Product Change Notice (PCN)

Subject: Notice of change in 14x14mm 64pin LQFP Tape & reel Packing Components for RA2E1
Publication Date: 5/10/2024
Effective Date: 8/1/2024

Difference of specification's detail (1)

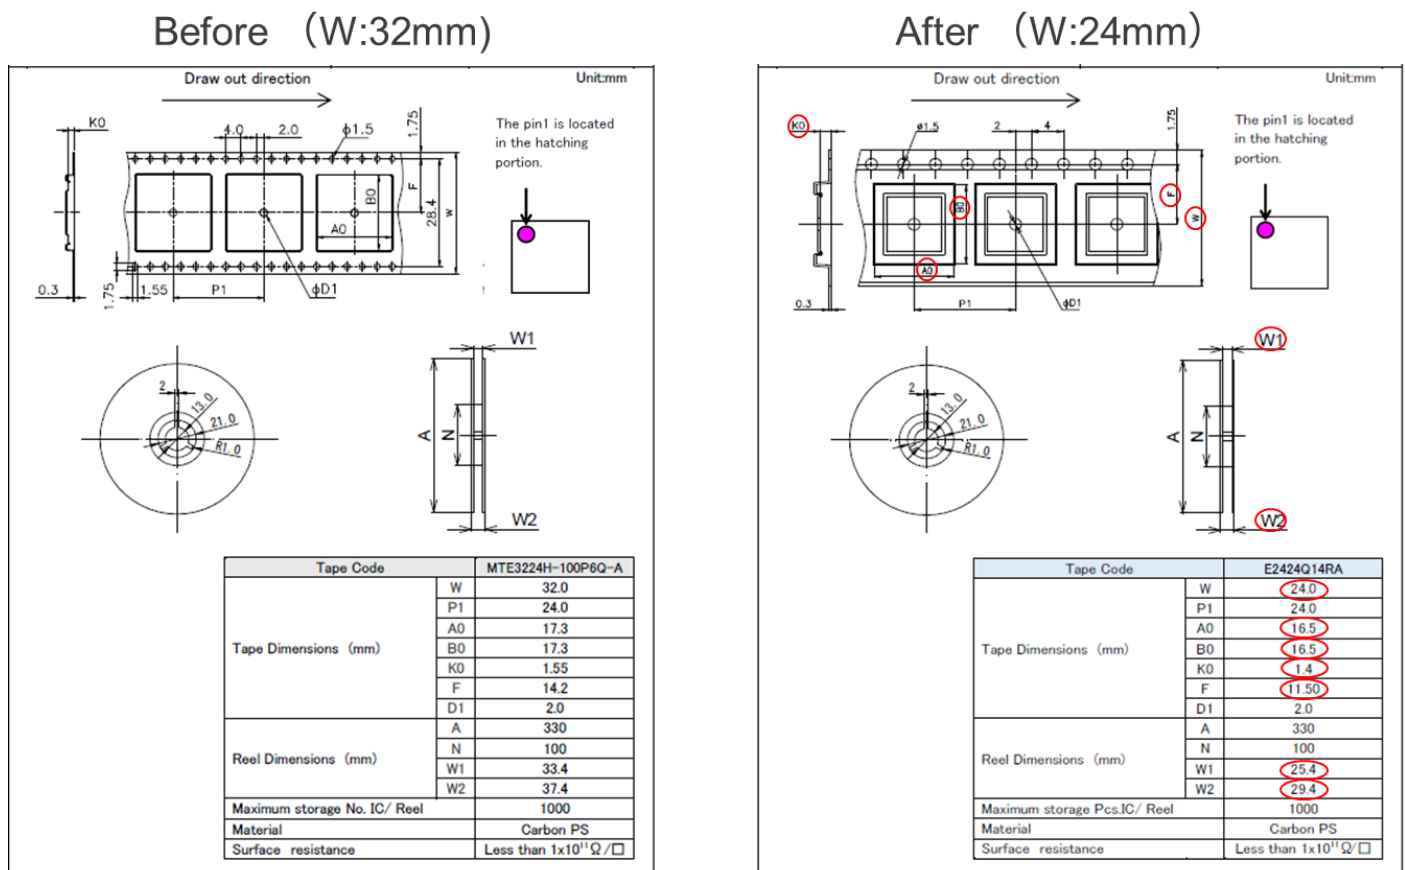
Applicable Products: RA2E1 Package dimensions 14x14mm 64pin LQFP
 Target location (assembly and testing base): Renesas Semiconductor (Beijing) Co., Ltd.
 Detail content: The embossed tape width will be changed for the shipment of tape & reel.
 Before change: 32 mm
 After change: 24 mm

The cavity width, cavity depth, sprocket hole, dimension between sprocket hole and cavity center, reel width, and cover tape width will be changed due to change in tape width.
